Transbay Transit Center San Francisco, CA CM/GC Contract No. 08-04-CMGC-000 Project No. 30100

BID PACKAGE TG07.3 ADDENDUM #7

DATE: 01/16/2015

MODIFIED DOCUMENTS PER ADDENDUM #7

TG07.3-105 Response

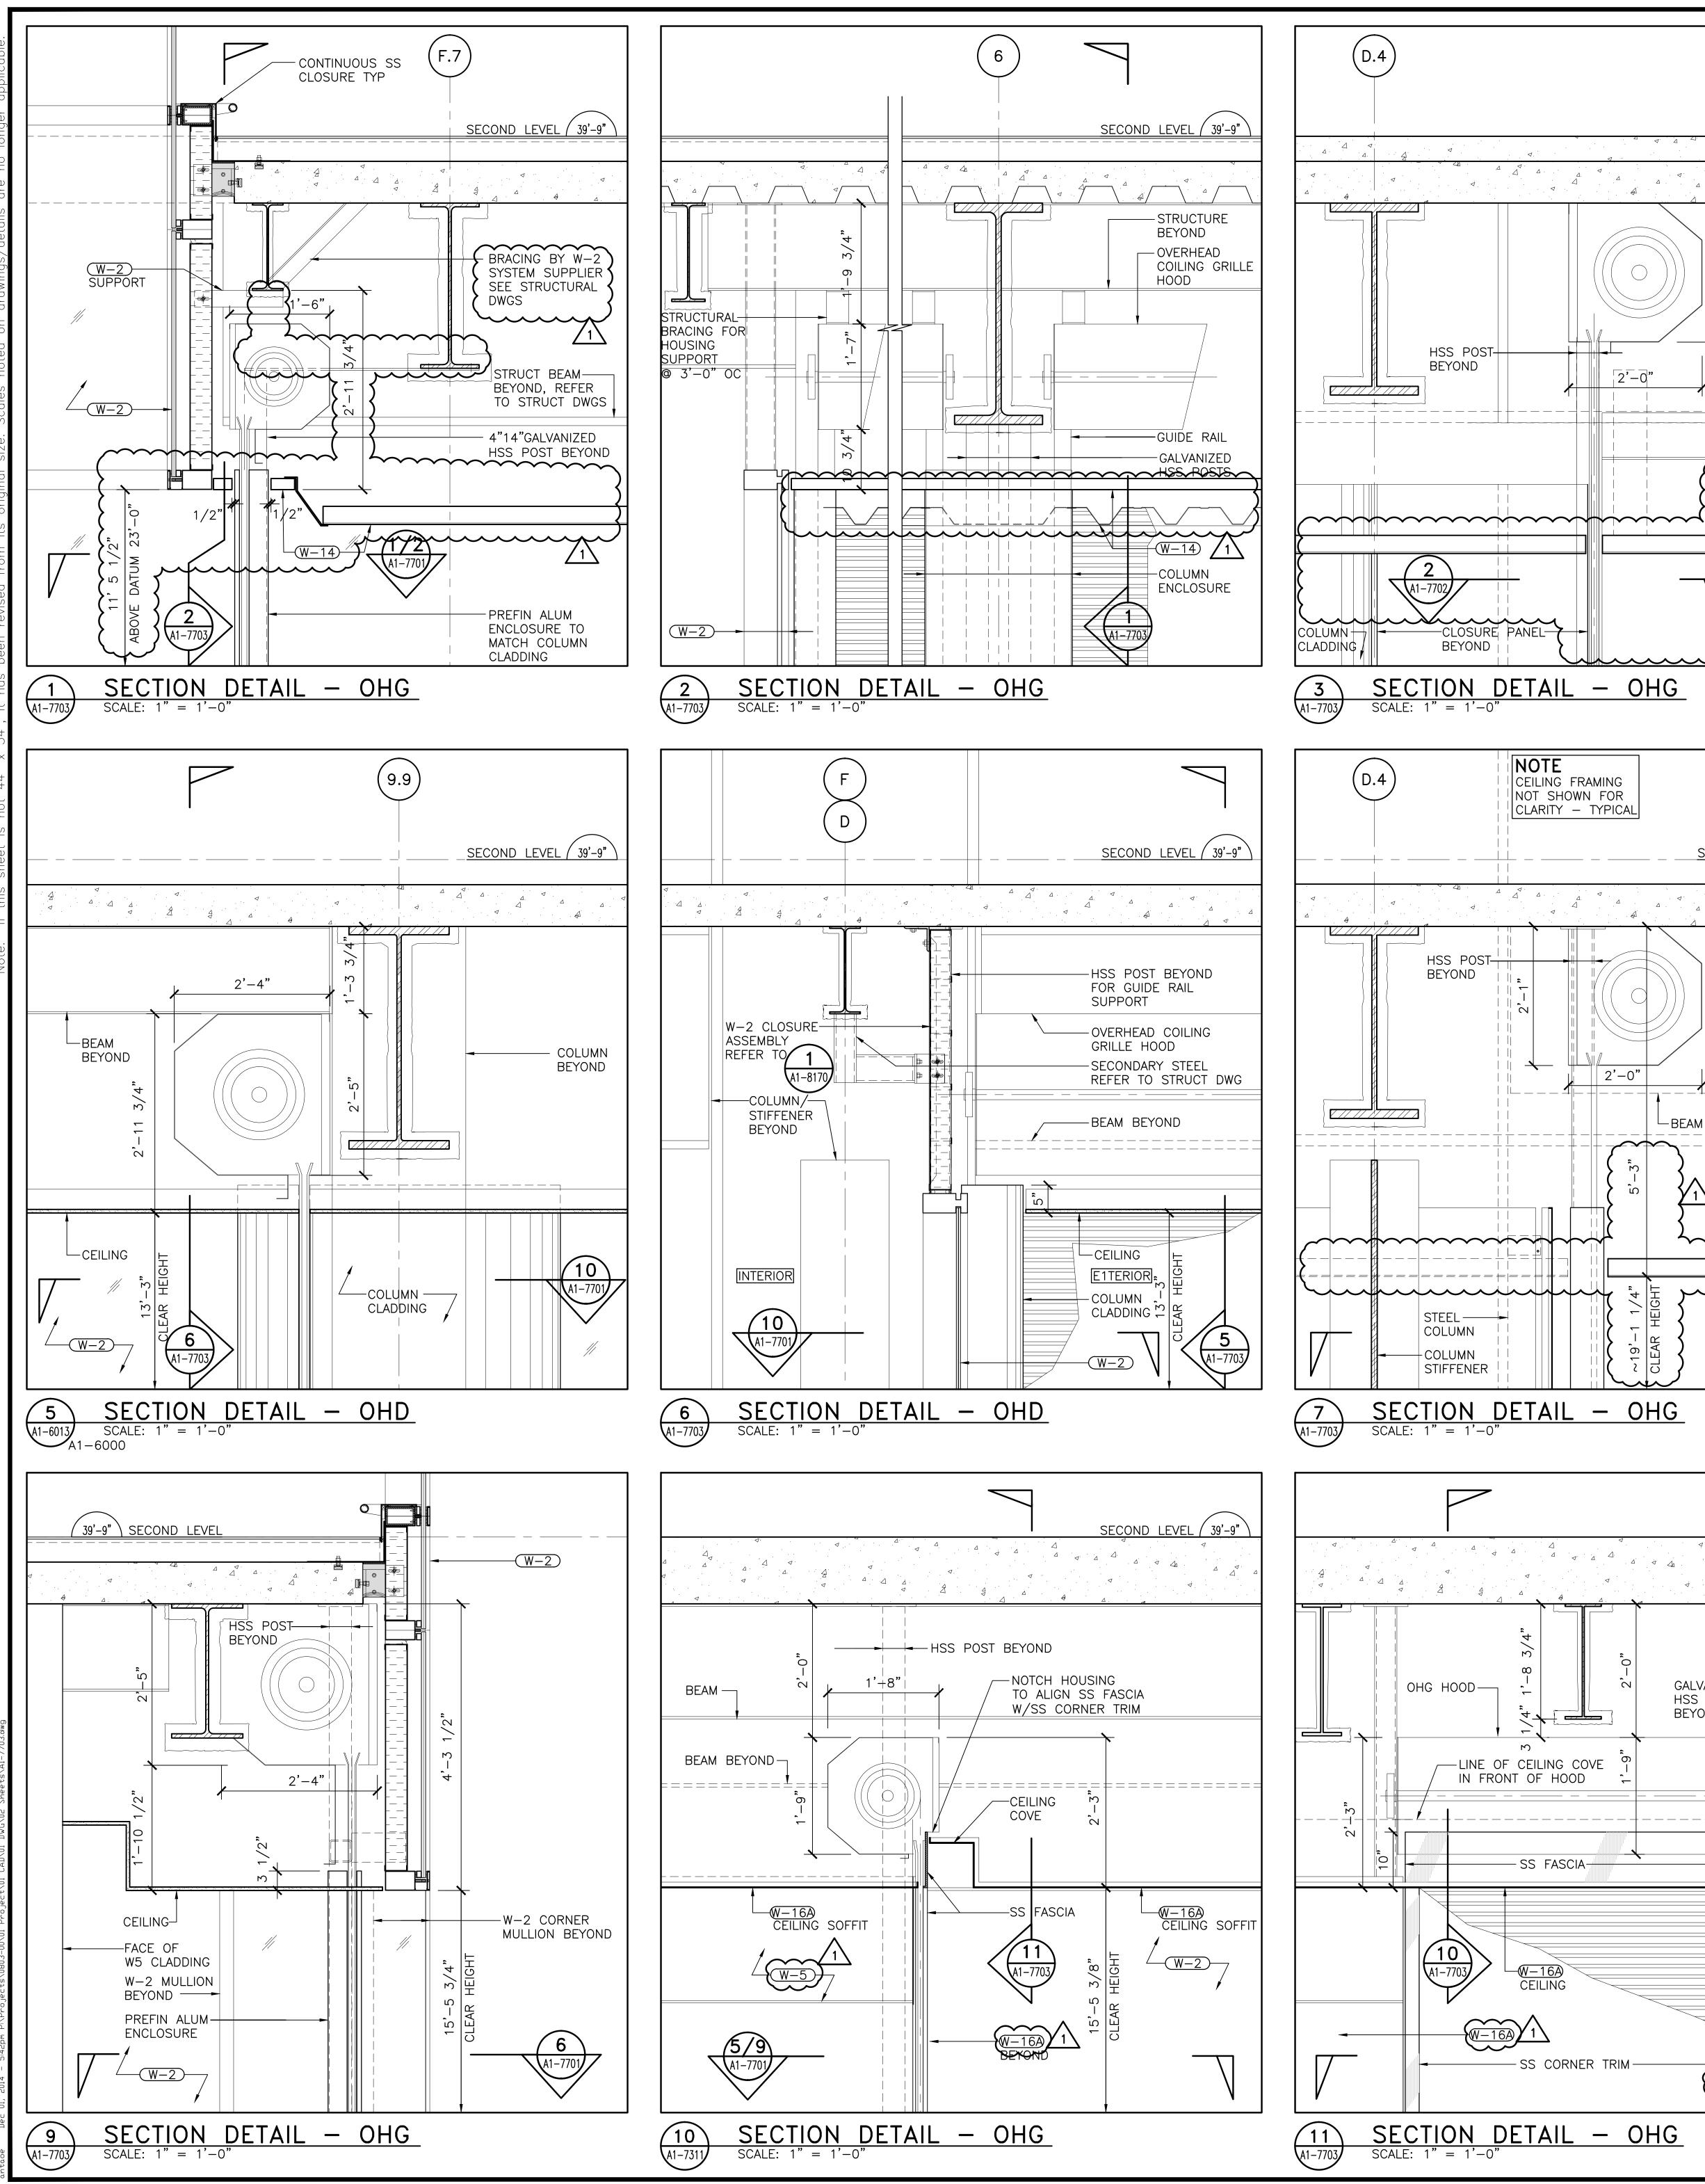
TG07.3- 105	11/6/2014	A1- 7576(Scope Dwg.), 4 & 5/A1-7577		Regarding the embed angle w/note "refer to struct dwgs"; Can you please provide a detail and location to where this angle is needed? Is this angle FOB? The clearest detail I have for the sill angles is 10/S1-7632, and I do not see this embed angle. Should I use another detail?	 The support angle will be needed at every elevator door sill; refer to Specification Section 14 21 00 – 2.16.G. The Detail 4/A1-7576 is to be used where there is a concrete topping slab. Detail 10/S1- 7632 is to be used where there is no topping slab. Detail 4/A1-7576 shall be revised per red marks in the attached sketch. Elevator sill support angles in Specification Section 05 50 00 Metal Fabrications are part of TG07.3 scope.
TG07.3- 106	11/6/2014	1/A1- 7703(Scope Dwg.)	Exhibit A / Item 34	Can you please provide a detail and spacing of "brace"? Is this bracing at all OHG's? Are we responsible for any other steel at the Overhead Grille's? (per Exhibit A; we own only overhead doors)	The bracing is for the W-2 system, to be provided by W-2 system supplier, not for overhead grilles and doors. Refer to structural drawings and attached architectural sketch SKA-4320. TG07.3 is responsible for bracing and supporting steel for overhead doors and grilles not integral to a "W" system
